DECISION OF THE PLANNING ADMINISTRATOR

**URBAN GROWTH PRELIMINARY DECLARATION / CLASS 3 SITE PLAN
REVIEW / CLASS 2 ADJUSTMENT / CLASS 1 ADJUSTMENT / CLASS 2
DRIVEWAY APPROACH PERMIT / CLASS 1 DESIGN REVIEW / PROPERTY
LINE ADJUSTMENT CASE NO.: UGA-SPR-ADJ-DAP-DR-PLA24-03**

REQUEST: An Urban Growth Area Preliminary Declaration to determine the public facilities required to serve the subject property, a Class 3 Site Plan Review and Class 1 Design Review for the development of a new 405-unit multi-family residential development, Class 2 Driveway Approach Permits for four new driveway approaches on proposed Lunar Drive NE, a Property Line Adjustment to eliminate an interior lot line, and the following Adjustments:

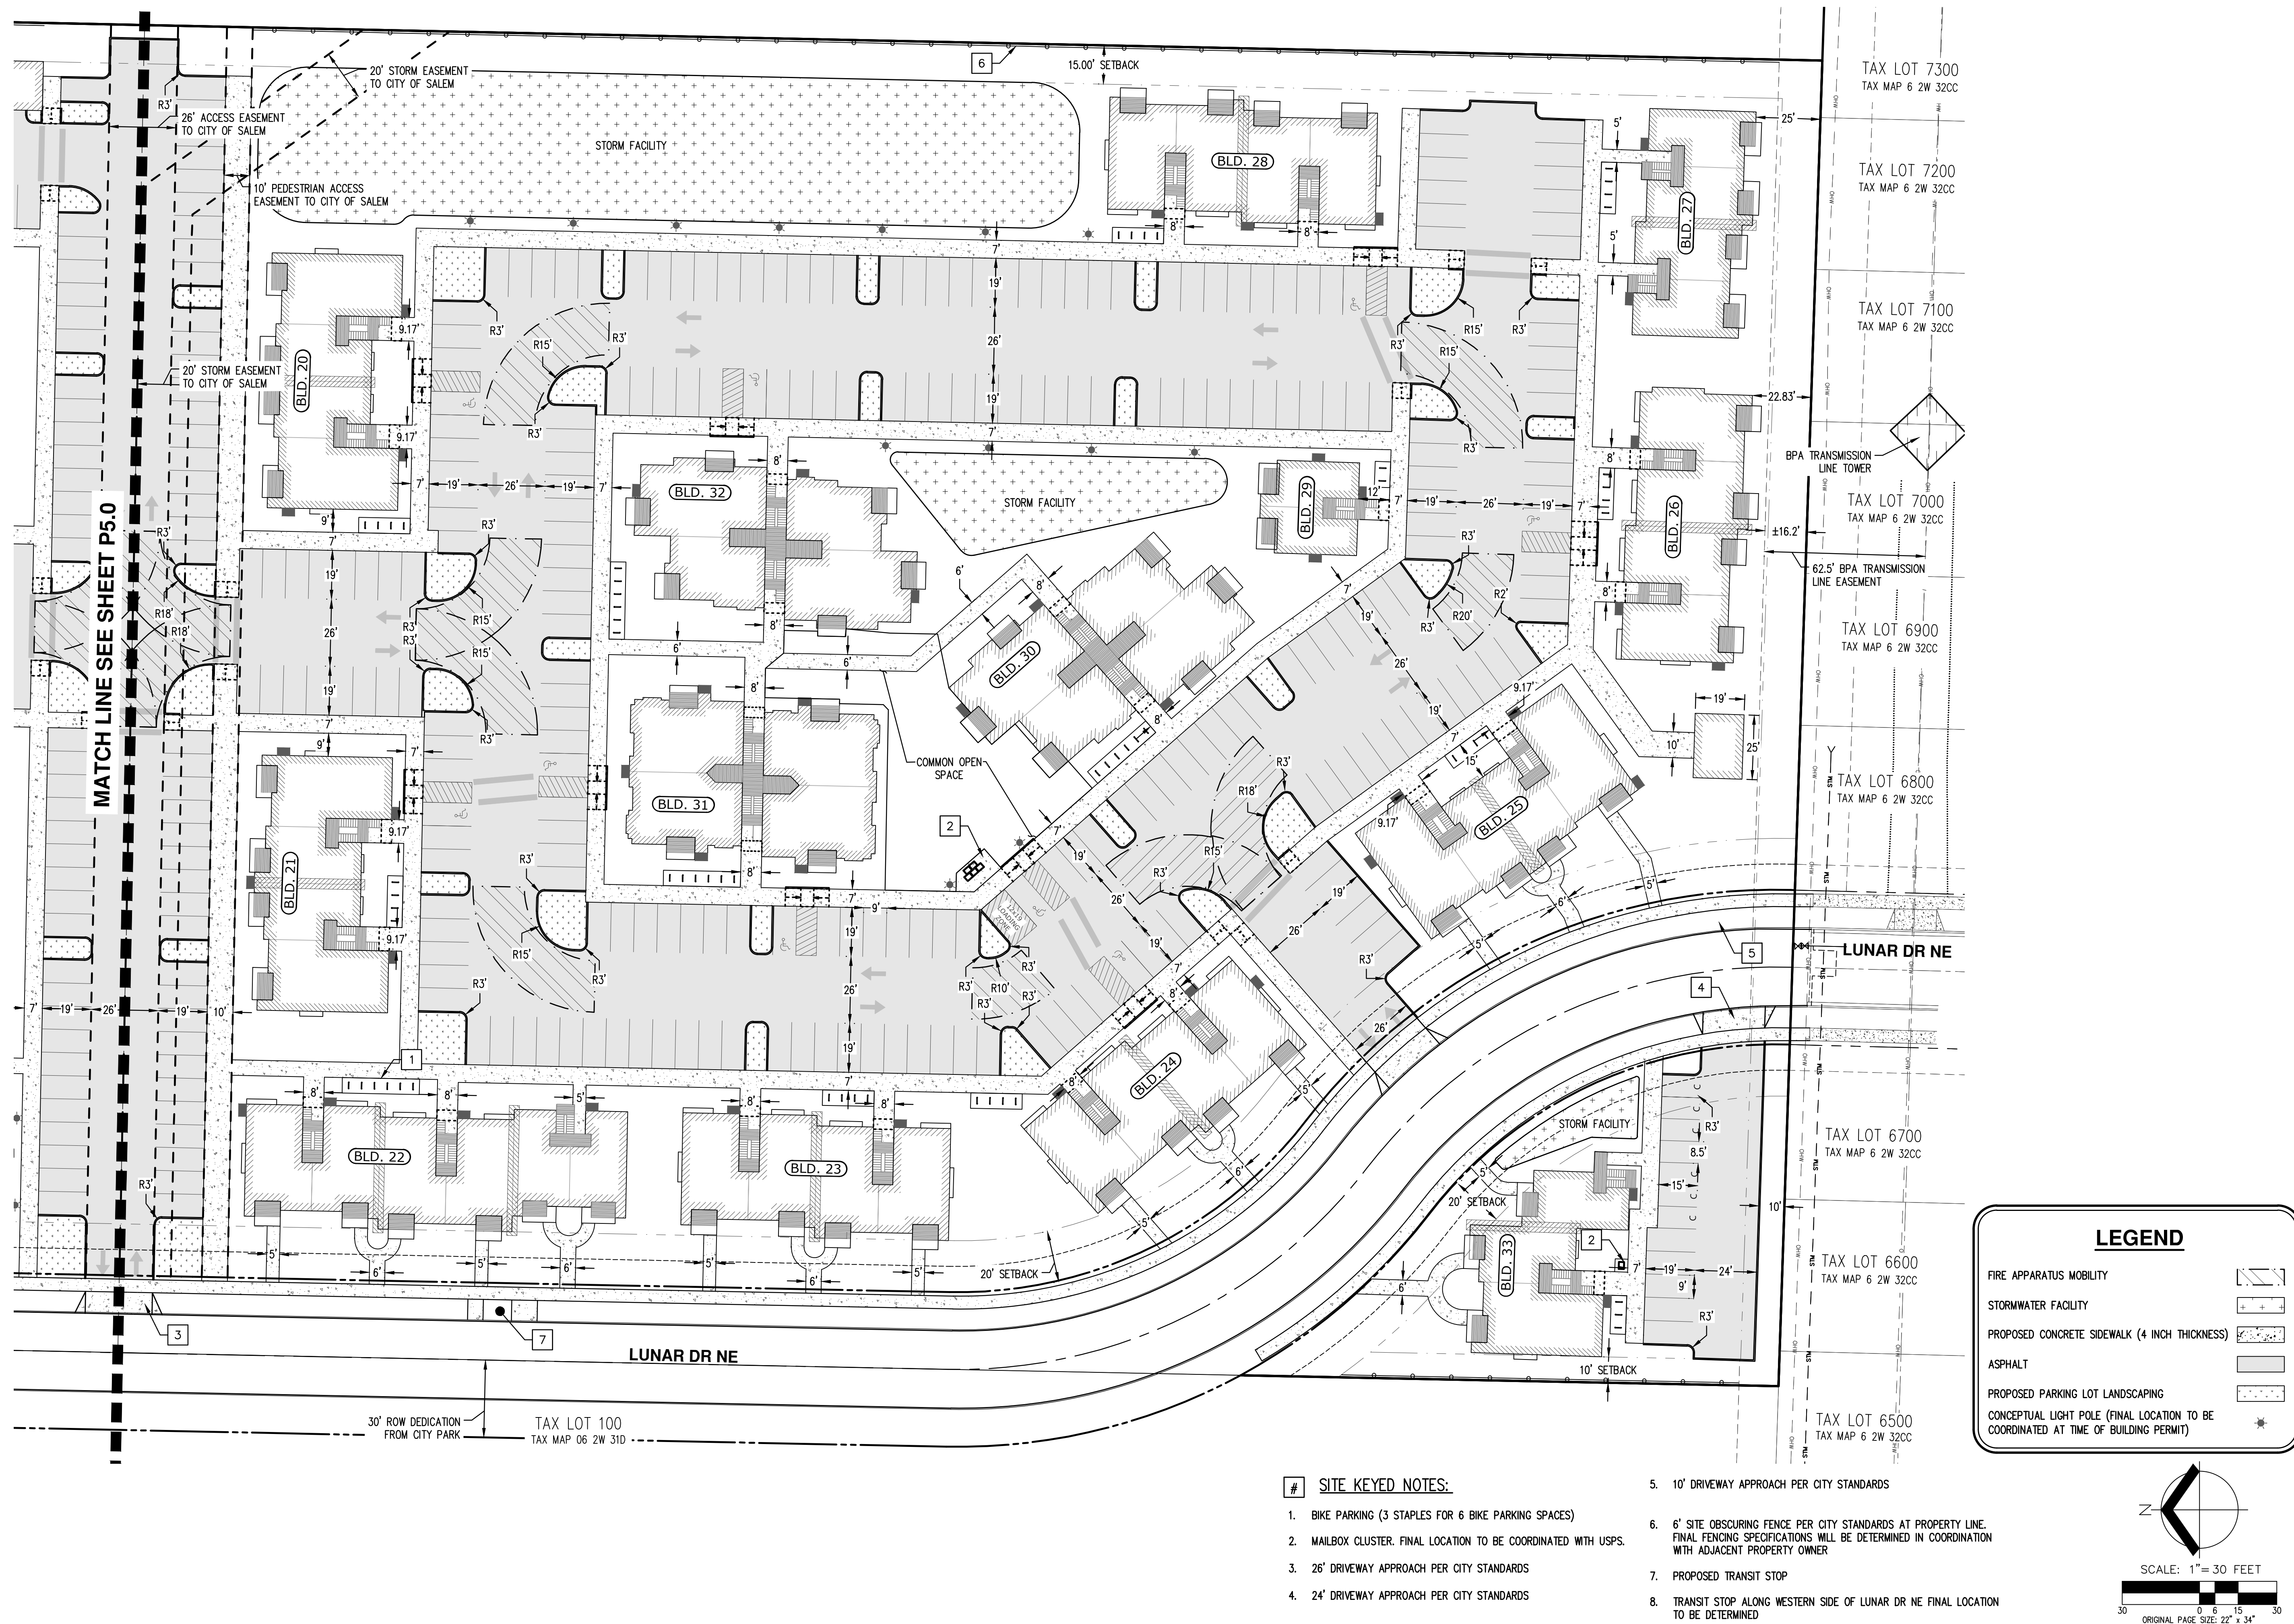
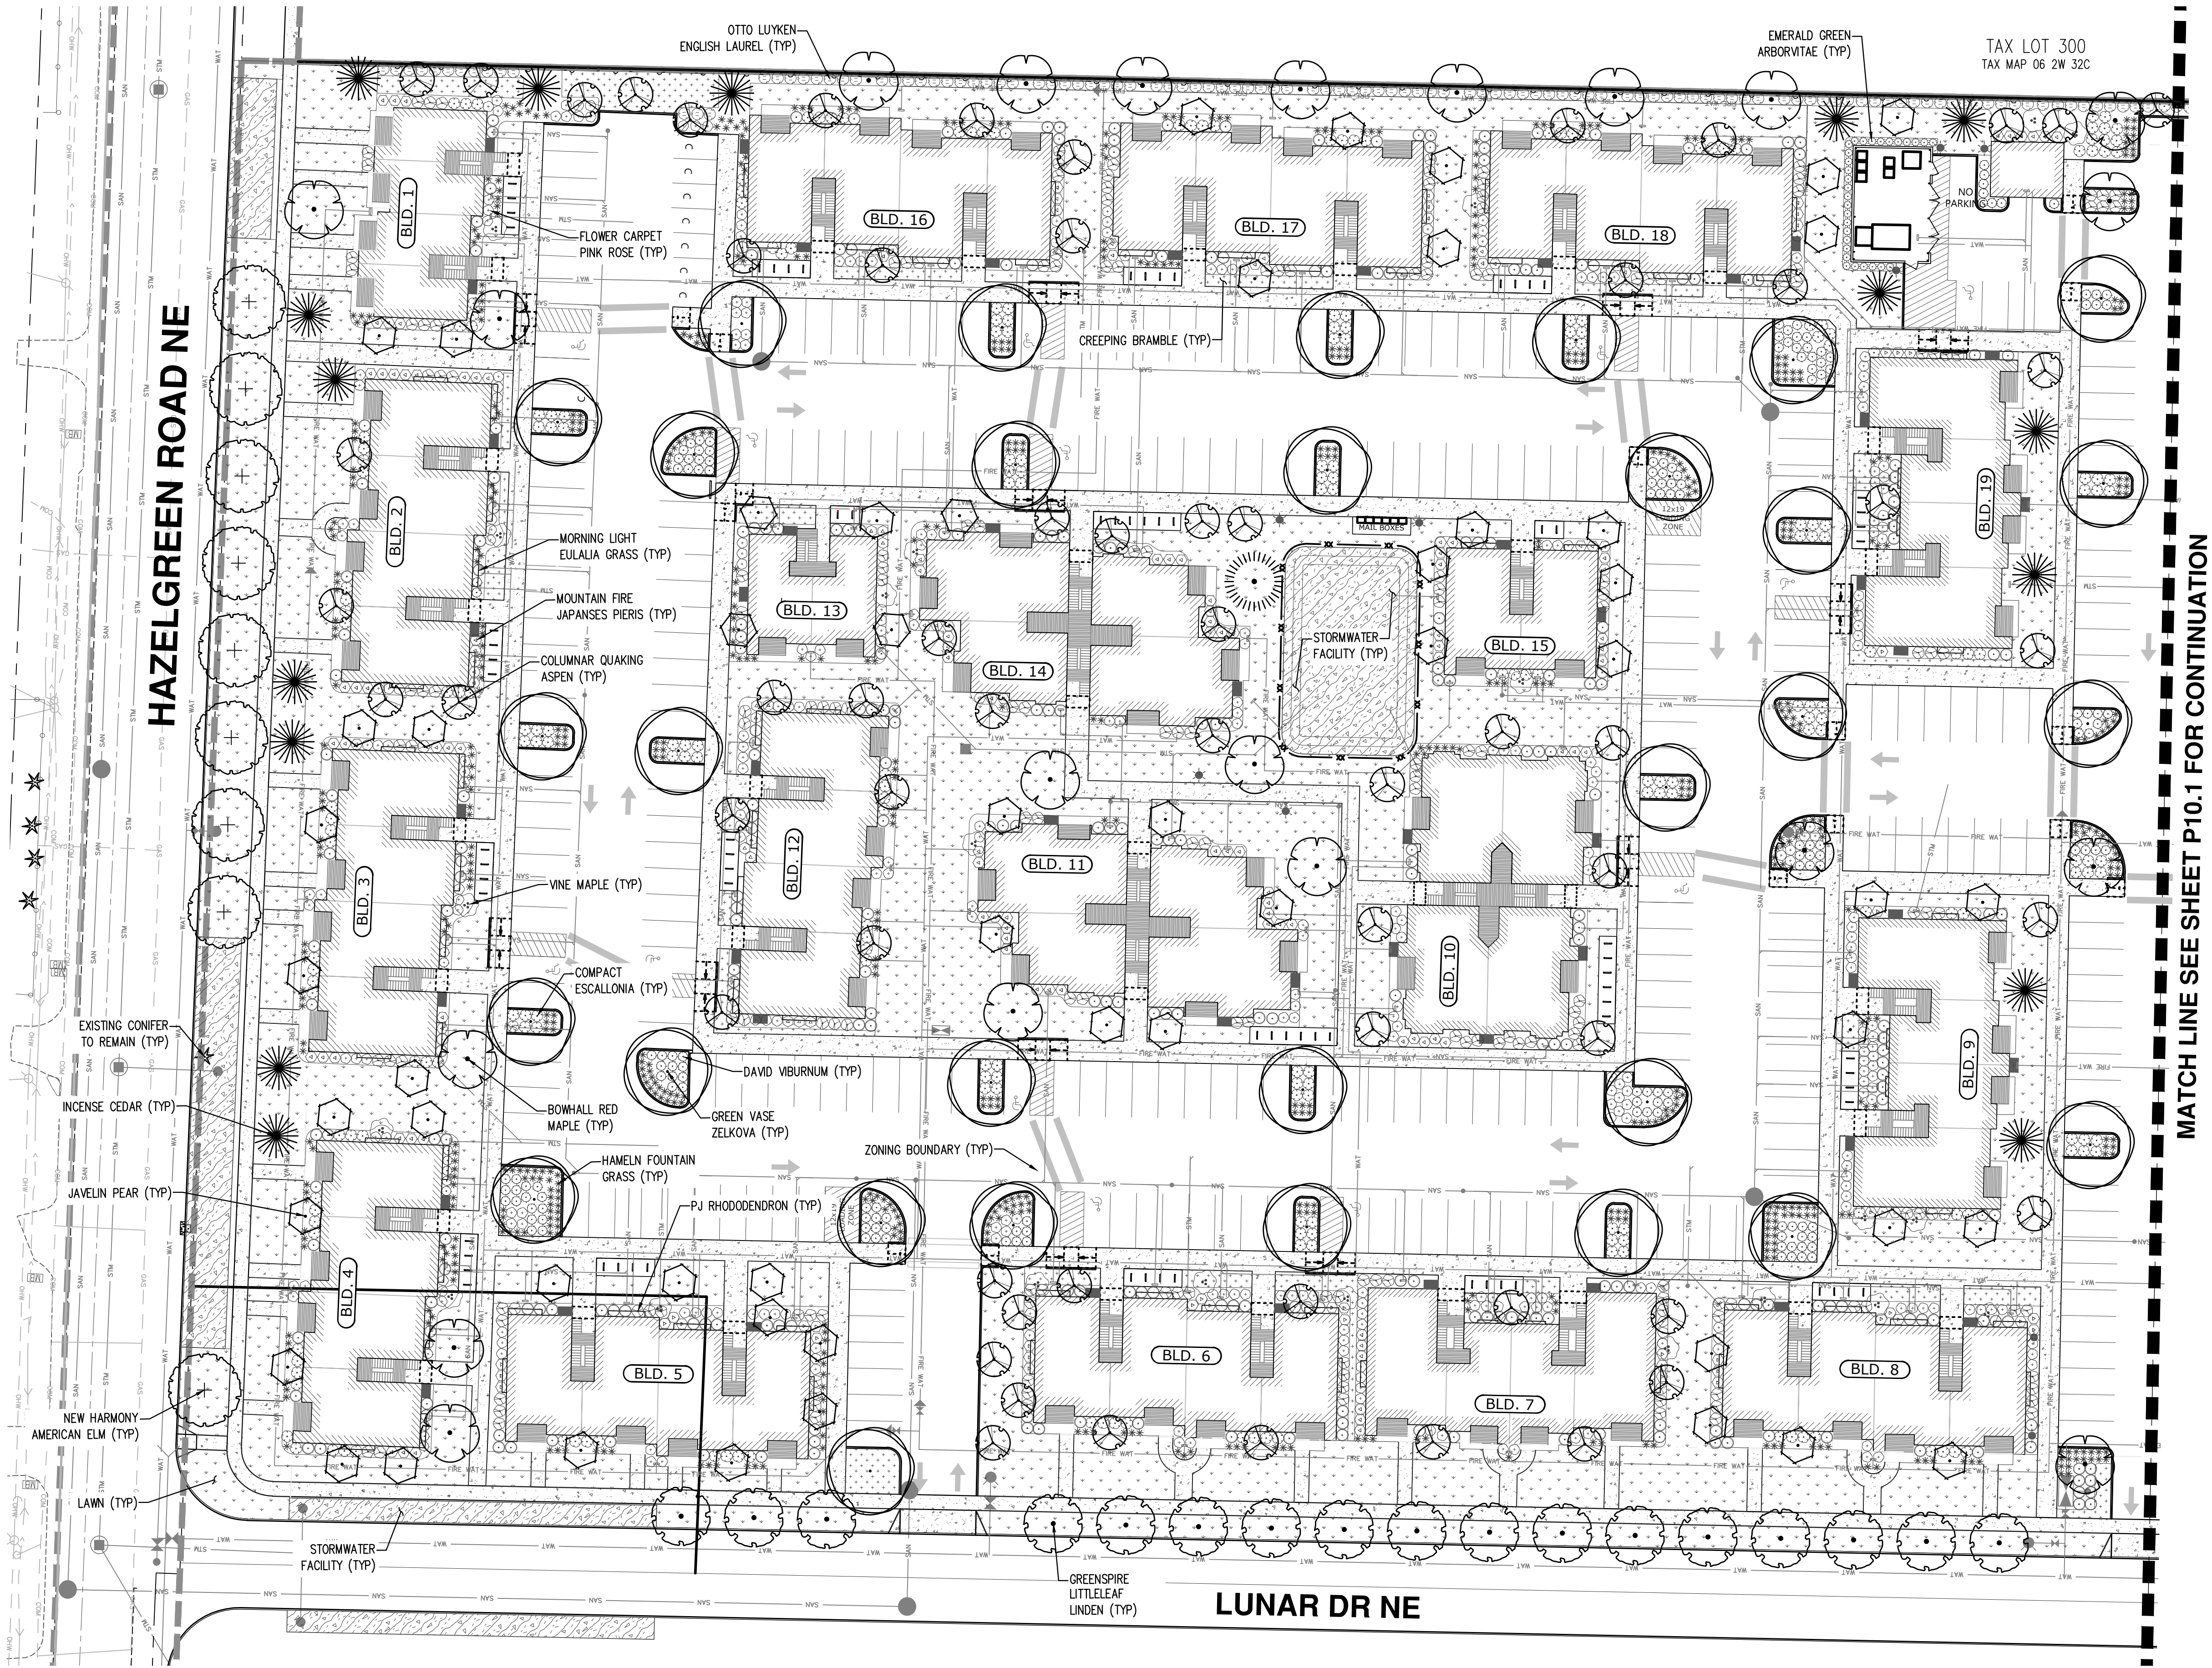
- 1) Hydrant and FDC shall not obstruct Fire Department access with hose lay. See sheet P7.0 near buildings 5 and 6.
- 2) Buildings that exceed 30 feet in height per the Oregon Fire Code require aerial access, 30-foot minimum. Appendix D105.3 as amended in SRC Chapter 58.
